## **2.5 Geology, Seismology, and Geotechnical Engineering**

In Section 2.5, "Geology, Seismology, and Geotechnical Engineering," of the SSAR, SERI provided a detailed description of the geological, seismological, and geotechnical engineering properties of the ESP site. In this SER, Section 2.5.1, "Basic Data," describes basic geological and seismological data, especially the data published since 1986 for the area within a 200-mile radius of the ESP site, and presents updated seismic sources. Section 2.5.2, "Vibratory Ground Motion," evaluates the vibratory ground motion for the ESP site and analyzes the safe-shutdown earthquake (SSE) ground motion. Section 2.5.3, "Surface Faulting," describes the potential for surface faulting at or near the surface of the ESP site. Section 2.5.4, "Stability of Subsurface Materials and Foundations," presents the results of site geotechnical investigations and discusses the stability of subsurface materials and foundations. Section 2.5.5, "Stability of Slopes," defers the analyses for slope stability at the site and dam performance, respectively, to the COL stage. Finally, Section 2.5.6, "Embankments and Dams," briefly states that no embankments e

**Figure 2.5.2-1 (SSAR 2.5-57) Deaggregation for low-frequency ( $S_a$  1–2.5 Hz) ground motions at the GGNS ESP site**

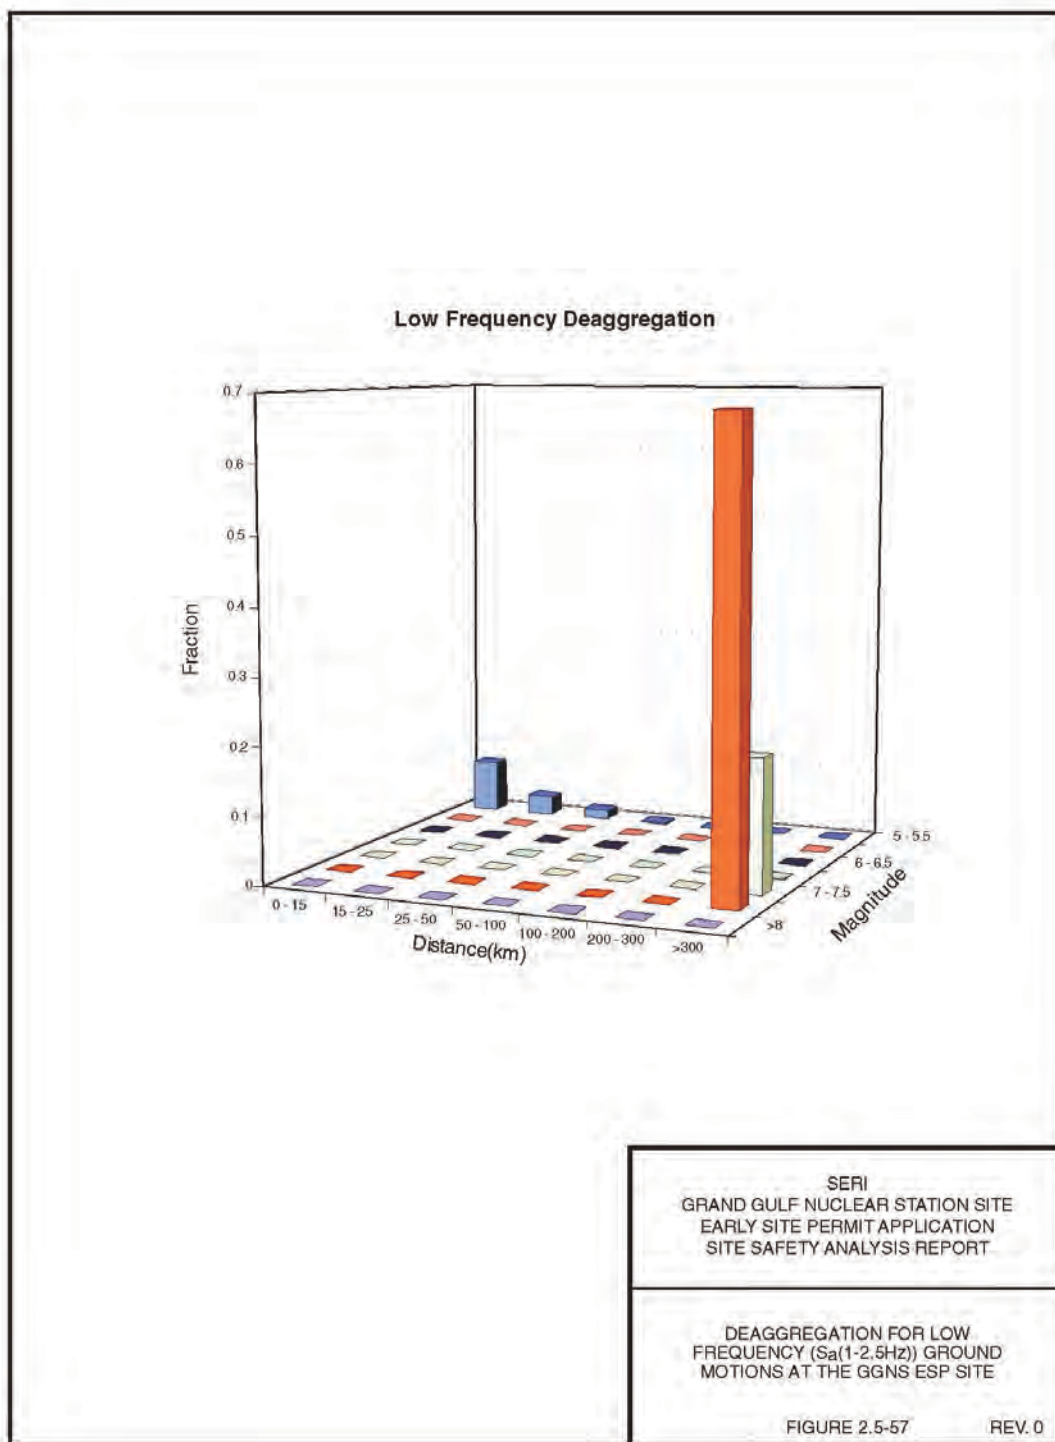
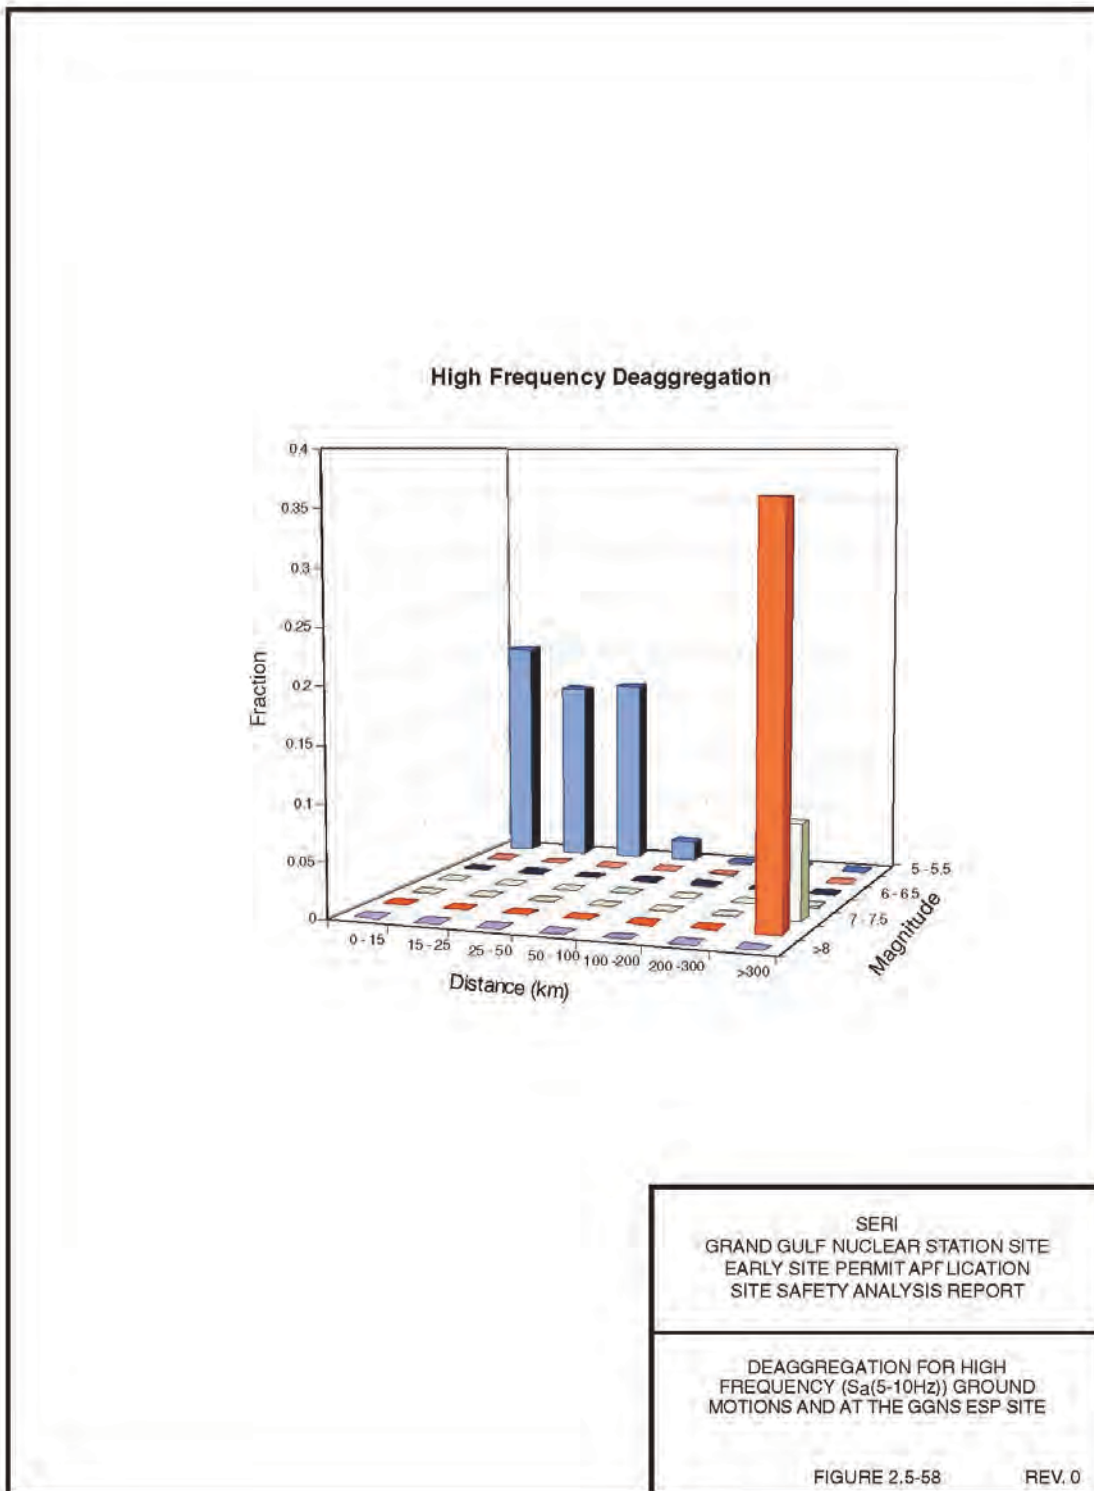
In RAI 2.5.2-9, the staff asked the applicant to explain why the SRSZ, with a magnitude as large as 6.0–7.0 and a distance at 81–206 miles, makes no contribution to the deaggregation results. In its response, the applicant stated the following:

In RAI 2.5.2-10, the staff asked the applicant explain why the magnitude-distance bin, including the controlling earthquake, does not contribute to the high-frequency deaggregation. In its response, the applicant stated that the controlling earthquake for a given frequency range is the mean magnitude and mean distance of the deaggregation distribution. If deaggregation is multimodal or bimodal as in the Grand Gulf case, the resulting mean may not correspond to the magnitude values that are actually defined in the distribution.

In RAI 2.5.2-9, the staff asked the applicant to explain why the magnitude and distance bins corresponding to the SRSZ make no contribution to the deaggregation result, although the SRSZ maximum earthquake magnitude is as large as 6.0–7.0 and at a distance of 81–206 miles from the ESP site. The applicant stated that the overall rate of earthquake occurrence ( $M_w$  greater than 5) at these distances for the SRSZ was too low to contribute to the  $10^{-5}$  median hazard. However, the staff notes that in SSAR Section 2.5.2.1.3 and in its response to RAI 2.5.1-3, the applicant stated that the activity of the SRSZ has a probability of 0.5 for its existence. This probability of existence implies that the SRSZ has a 50 percent chance to produce an earthquake with a magnitude between 6.0–7.0. The applicant also assigned three different return periods (388, 1725, and 3505 years) to the characteristic SRSZ earthquake model based on paleoliquefaction data. As such, a SRSZ earthquake with a 3,505-year return period should repeat about 30 times during the 100,000-year time span that is associated with a  $10^{-5}$  probability of exceedance. Therefore, the staff was not certain why the magnitude and distance bins corresponding to the SRSZ do not contribute to the hazard at the  $10^{-5}$  probability level.

The purpose of the magnitude-distance deaggregation is to provide a measure of the relative contribution of events (of different magnitude-distance pairs) to the total hazard. The deaggregation graphs in the SSAR show the relative contribution of earthquakes to the  $10^{-5}$  median. The fact that events associated with the Saline River source (and all sources in this distance range) do not contribute to the  $10^{-5}$  median hazard for the Grand Gulf site is primarily due to the fact that the overall rate of earthquake occurrences ( $M_w > 5$ ) at these distances is extremely low. Further, the rate of occurrence of earthquakes of magnitude 6.0–7.0 is thus much lower. The result is that the estimated ground motion hazard at the Grand Gulf site is extremely low and, in a relative sense, makes little or no contribution to the  $10^{-5}$  median hazard.

In response to the staff's evaluation, the applicant performed a sensitivity test to evaluate the impact of the missing SRSZ contribution to the controlling earthquakes. When increasing the hazard contribution from the SRSZ, the applicant balanced the total hazard by decreasing the hazard contribution from other sources, including the NMSZ, which ensured the NRC staff that the absence of the SRSZ contribution only caused by the applicant's deaggregation process. The applicant stated that the results from the sensitivity test indicate there is a very small change to the 5 and 10 Hz controlling earthquakes (see Table 2.5.2 -1) and associated median rock response spectrum. The calculated differences in response spectrum values ranges from +0.06 to -0.23 percent of the comparable Grand Gulf response spectra. The applicant concluded that even if the staff's approach were used to deaggregate the controlling earthquake, which shows that the SRSZ may contribute up to 5 to 10 percent of the median hazard, the contribution would not result in a significant change to the median rock ground motion at the Grand Gulf site. Based on the results of the applicant's sensitivity test and also the fact that the SRSZ is relatively far from the ESP site (130 to 329 km), the staff concurs with the applicant on its conclusion with regard to the specific situation of the ESP site. Therefore, this open item is resolved.

The applicant's response to RAI 2.5.2-10 adequately explained why the high-frequency deaggregation graph shows no contribution from the magnitude-distance bin that contains the controlling earthquake.
